## Edits and Additions to the Proposed Plan in Response to Public Comments

Downtown Station Area SP

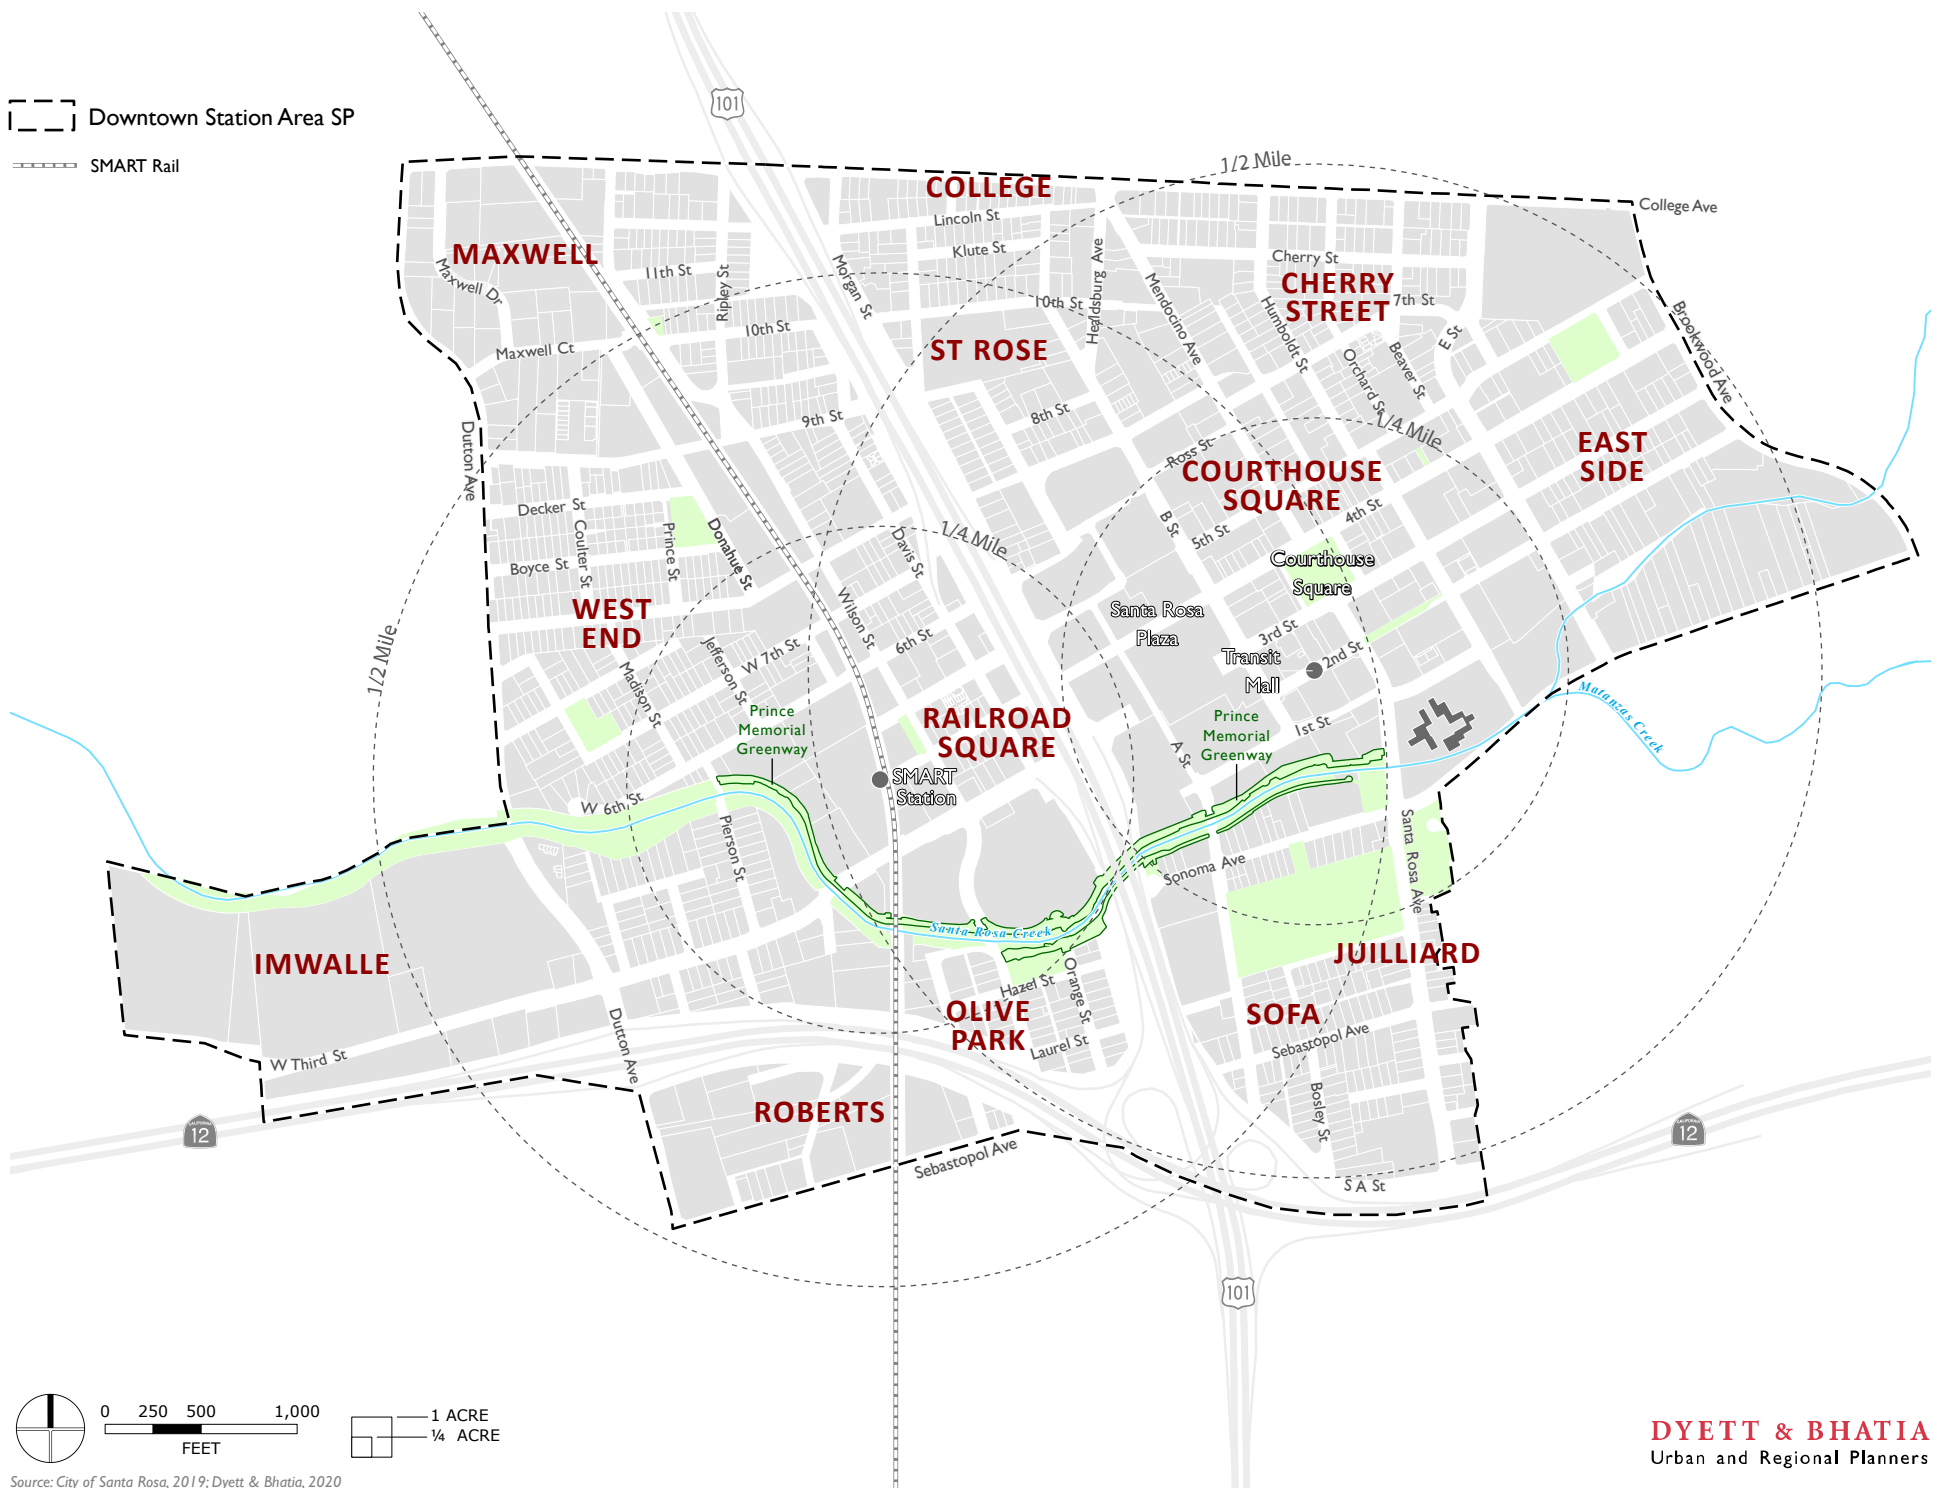
Introduction	1-9; 3-10; 3-11; 5-15	Keep consistent: <u>Citywide</u> Creek Master Plan
Introduction	Map Intro-1	Delineate Prince Memorial Greenway on Map INTRO-1
Land Use	2-2	Change Vacant Land description on Page 2-2 to state the following: Several large sites account for a large portion of this vacant land, including the SMART site west of the Downtown Station between West Third and West Sixth Streets and several properties in the <u>western portion</u> of the Downtown Station Area around Imwalle Gardens.

# LU-3: Land Use

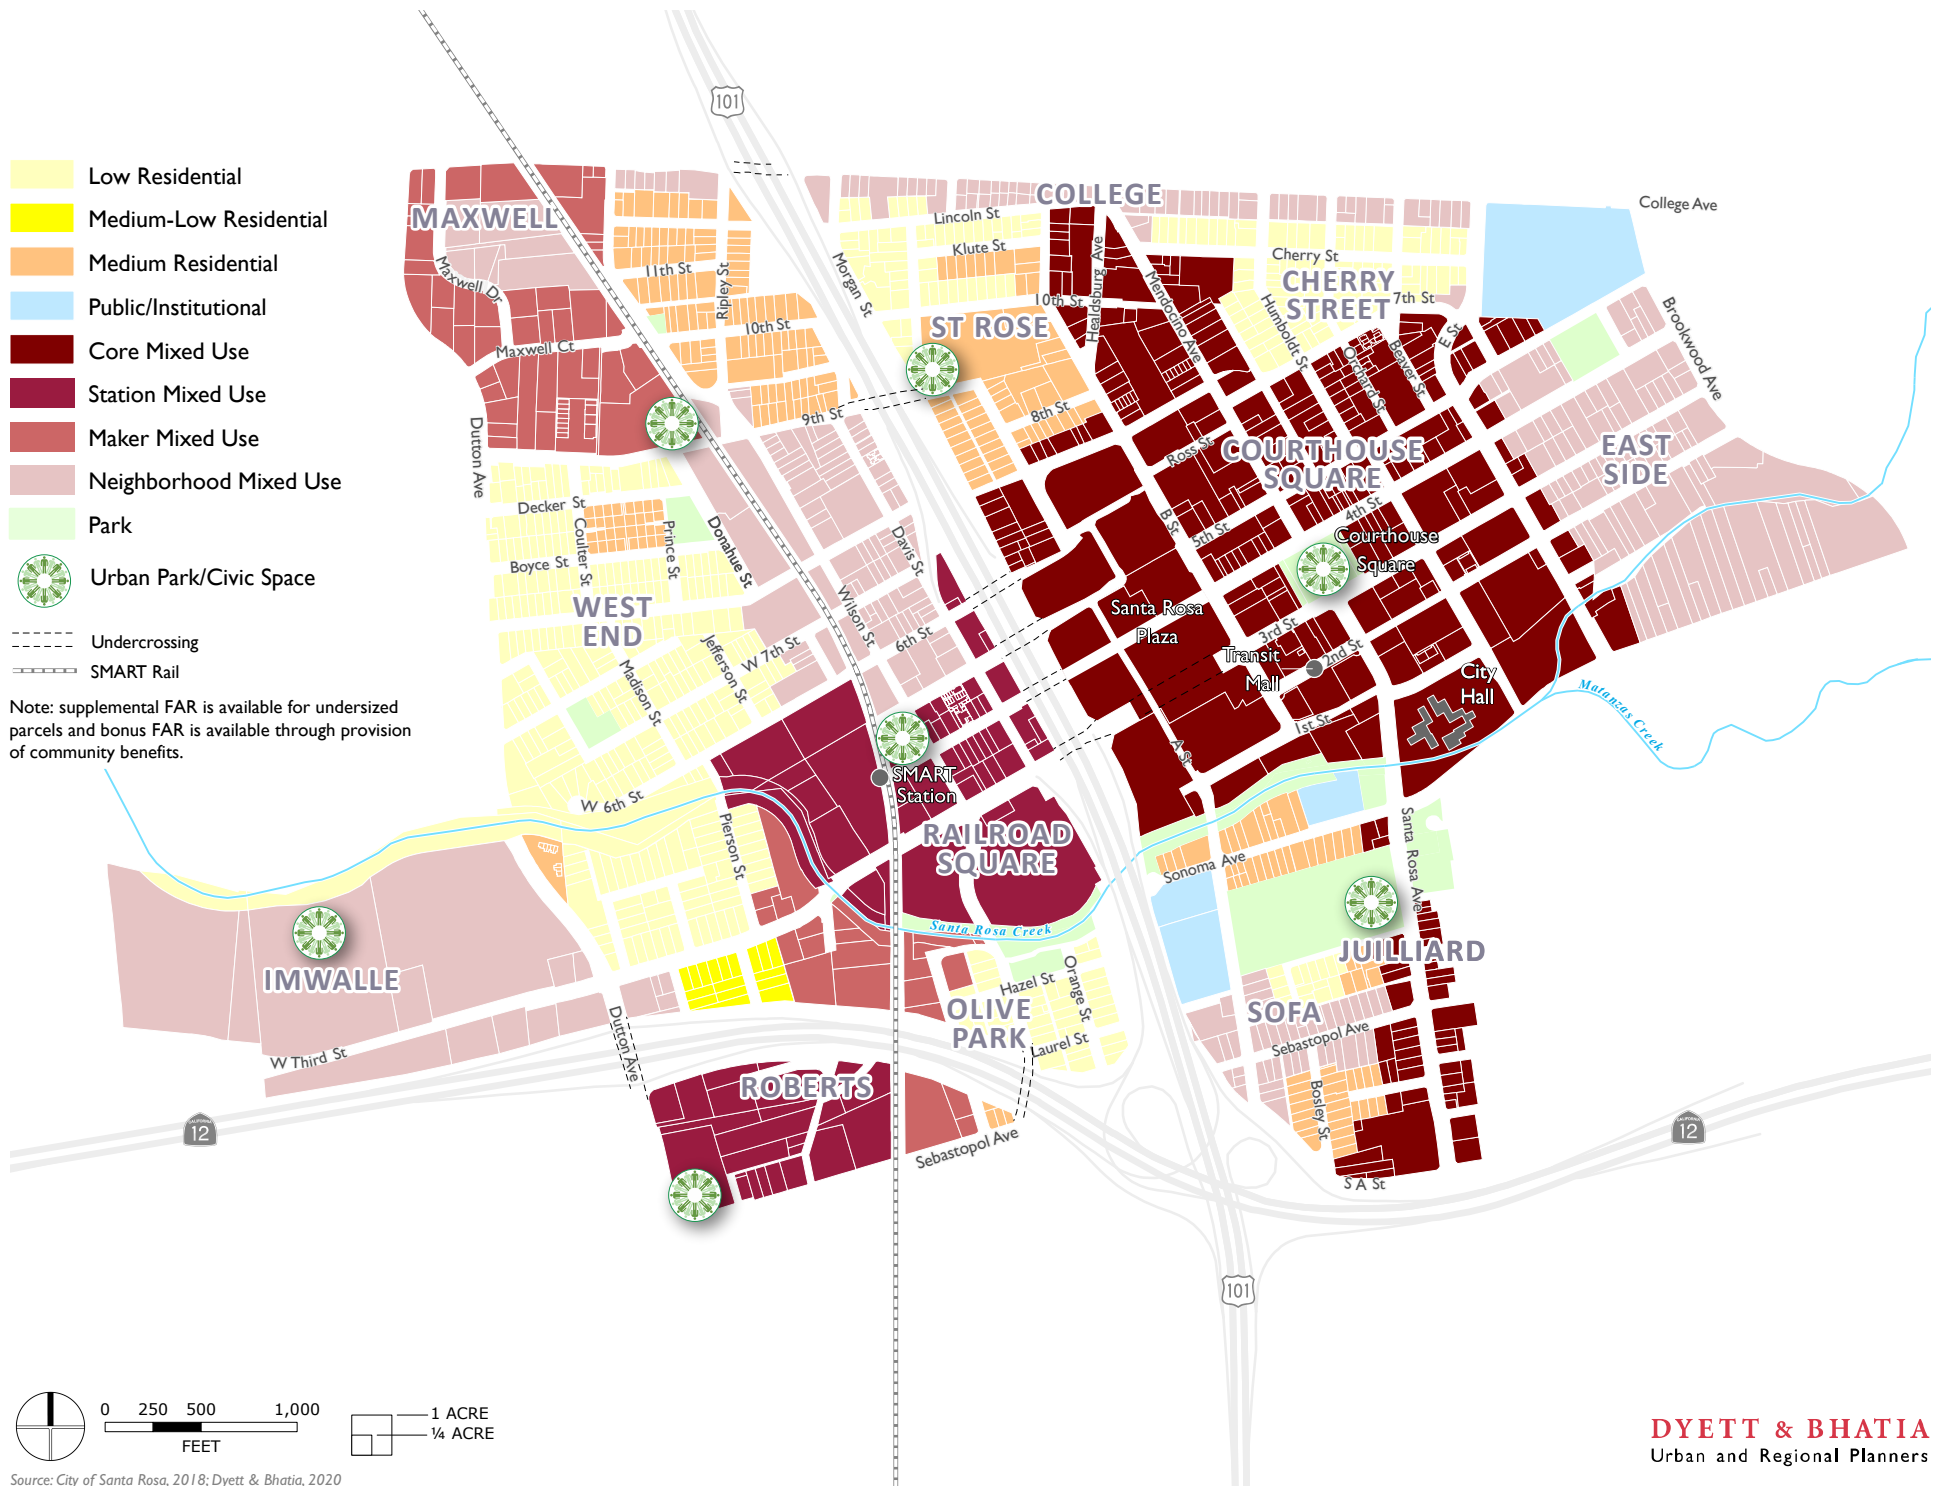
Land Use	2-17	Add Policy: Require new development within the Core Mixed Use, Station Mixed Use, Maker Mixed Use, and Neighborhood Mixed Use designations to achieve the mid-point or higher of the maximum FAR. Exceptions are allowed where parcel configuration, historic preservation or utility constraints make the mid-point impossible to achieve.
Land Use	2-17	LU-2.6: Require commercial uses that exceed 15,000 square feet to have a multi-storied format, rather than be spread out horizontally, and integrate other uses. Grocery stores are excepted from this requirement. Allow single-story development only if it can be shown to be complimentary and compatible with the vision and desired character for the area where it is proposed.
Land Use	2-19	Policy LU- 3.8- Replace "metro" chamber with "area" chamber of commerce groups
Land Use	Map Intro 1; Map LU-3	Remove "North Railroad Square" notation on map.

Land Use	Map LU-3, Map LU-5	Apply Neighborhood MU land use and max FAR of 2.0 for the properties on W. 3rd between Dutton and Decoe
Land Use	Map LU-3, Map LU-5, Map UDCS-1	Apply Core MU land use and max FAR of 4.0 for 526 Sonoma Avenue; add Neighborhood Transition to west-facing side of parcel
Land Use, Urban Design and Civic Spaces	Map LU-3, Map LU-5, Map UDCS-1	Apply Core MU land use and max FAR of 3.0 for two blocks on B Street north of Healdsburg Avenue up to Lincoln Ave. (Core Mixed Use - FAR 3). Add Neighborhood Transition to parcels fronting B Street.
Land Use	Map LU-5	Apply max FAR of 4.0 for one block on B Street between 7th Street and Healdsburg Avenue (Core Mixed Use - FAR 4).
Mobility	3-2	Replace "Vehicle Miles Traveled" header with "Performance Metrics"
Mobility	3-4	Edit Policy MOB-1.1 to clarify as follows: Maintain a roadway classification system as illustrated in Figure MOB-1, with the following segments as Boulevards designed to accommodate transit, bicycles, and pedestrian facilities together with vehicle traffic: * <u>Santa Rosa Avenue from Sonoma Avenue to South A Street</u> * <u>E Street from Sonoma Avenue to College Avenue</u>

# MOB-1: Roadway Classifications

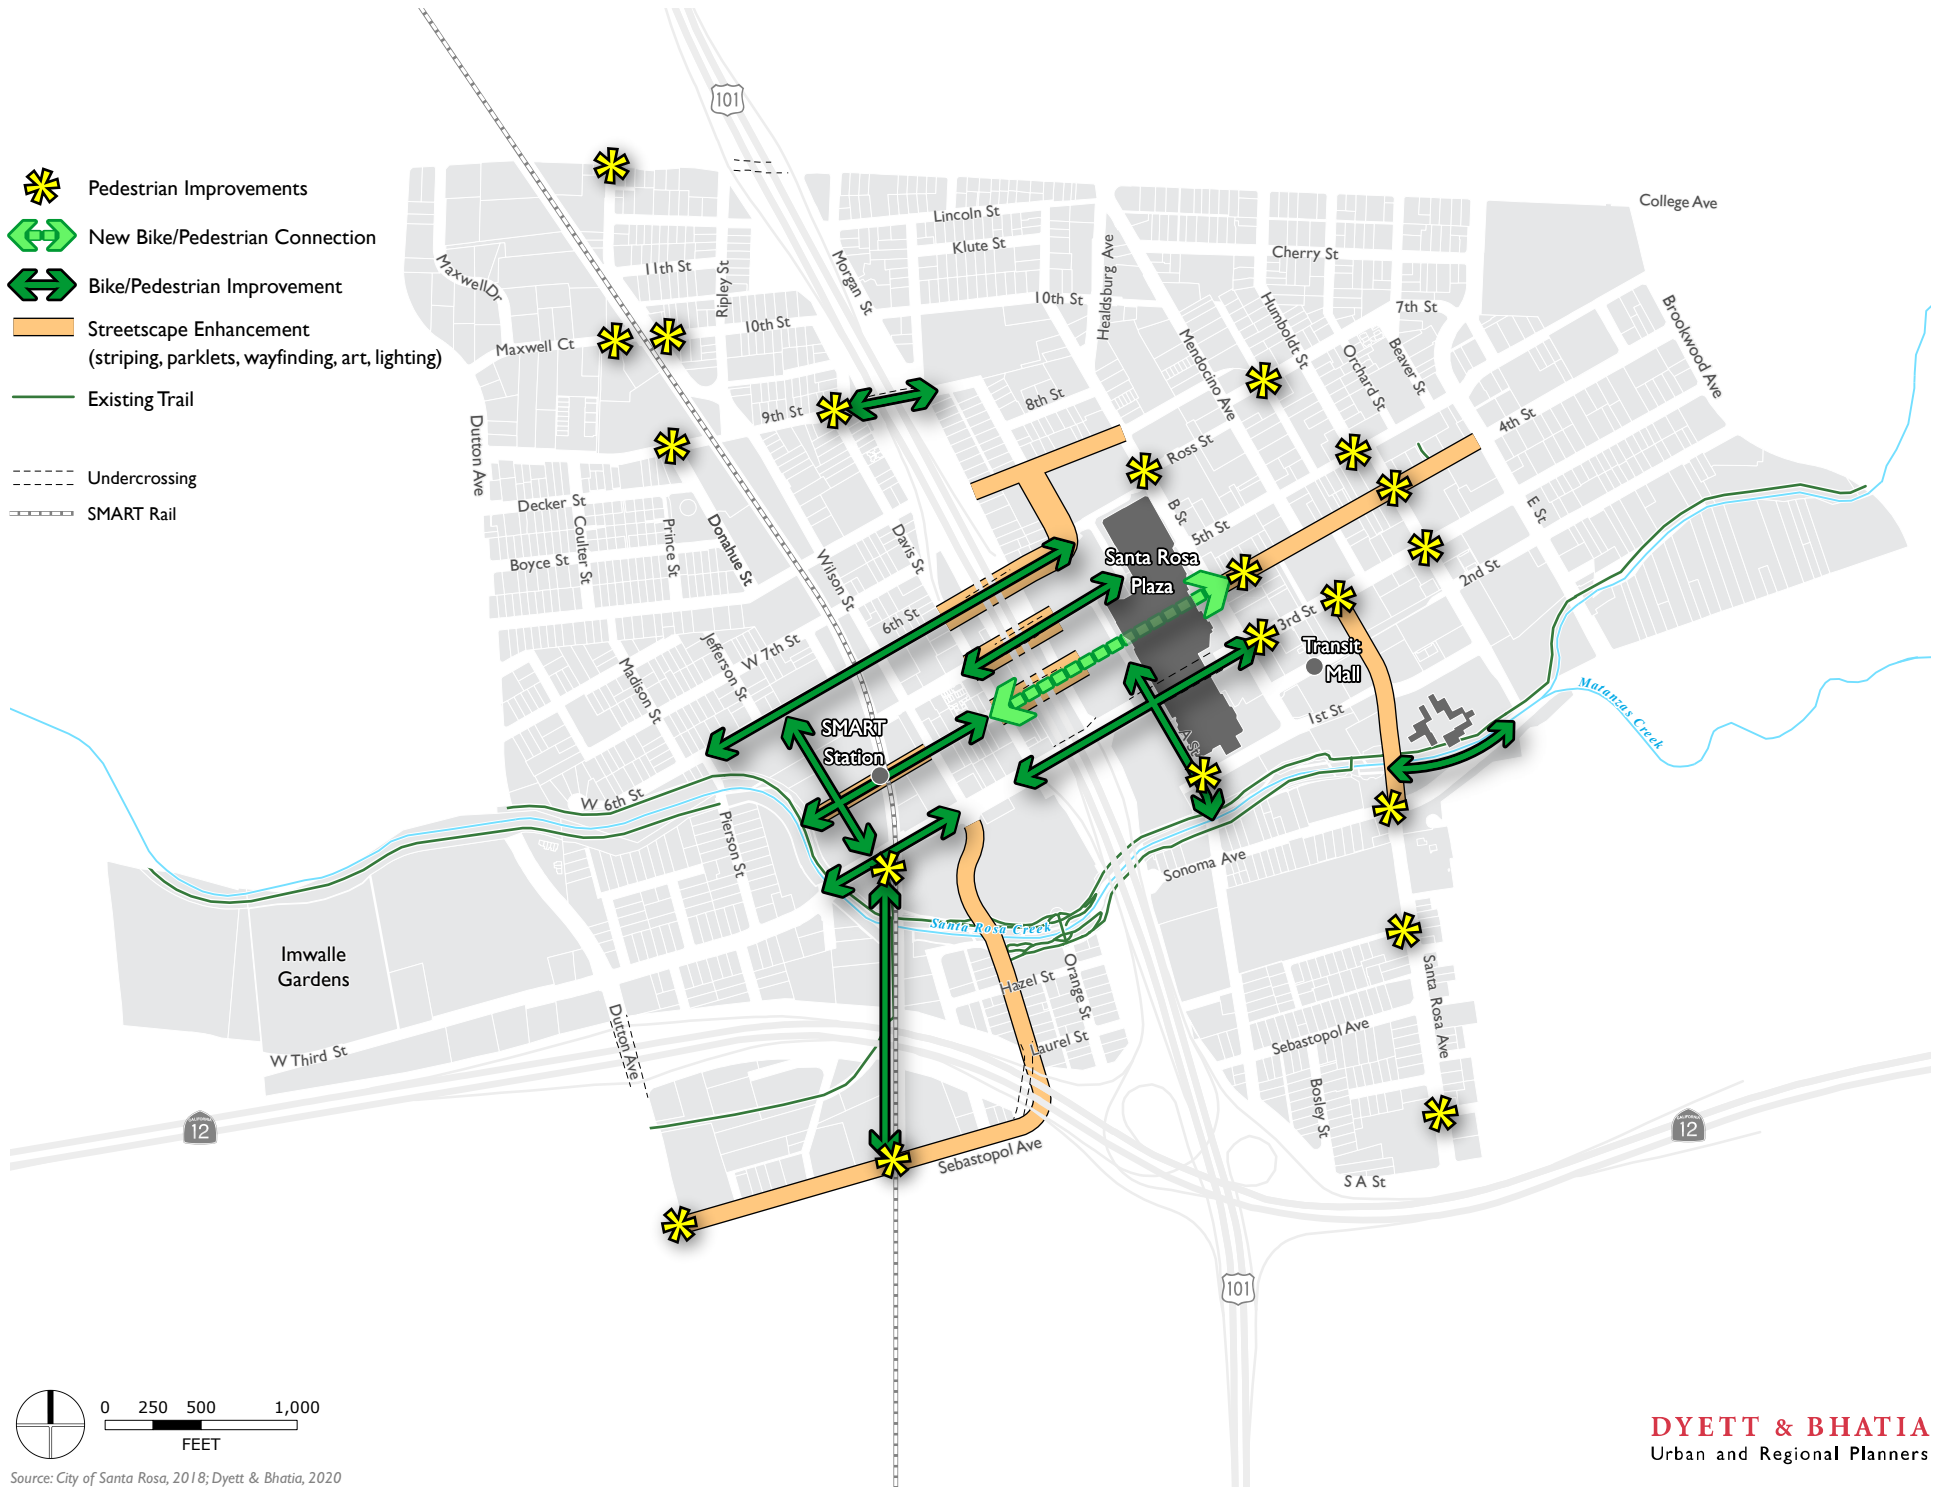
Mobility	3-5	Change Roberts Road to Roberts Avenue in Table MOB-1
Mobility	3-10	Add language to East-West connections describing Prince Memorial Greenway/Santa Rosa Creek trails as an east-west connection
Mobility	3-11	Downtown Loop. A strengthened transit connection along <u>Third Street</u> will link Courthouse Square, the Sonoma-Marin Area Rail Transit (SMART) station <u>and the regional Joe Rodota Trail</u> , whether by way of a trackless trolley, enhanced CityBus service, or on-demand electric vehicle (see Map MOB-5).
Mobility	3-13	New Policy: Promote pedestrian and bicycle connections to the Prince Memorial Greenway and Santa Rosa Creek Greenway to provide an east-west connection across the planning area.
Mobility	3-13	Change Policy: MOB-2.2 Connect southbound bicycle infrastructure on B Street between <del>Third</del> <u>First</u> and Fourth streets with a Class II bicycle lane.
Mobility	3-13	New Policy: Identify maintenance needs and funding mechanisms for the Prince Memorial Greenway to improve and maintain the corridor to accommodate a variety of passive and active uses.
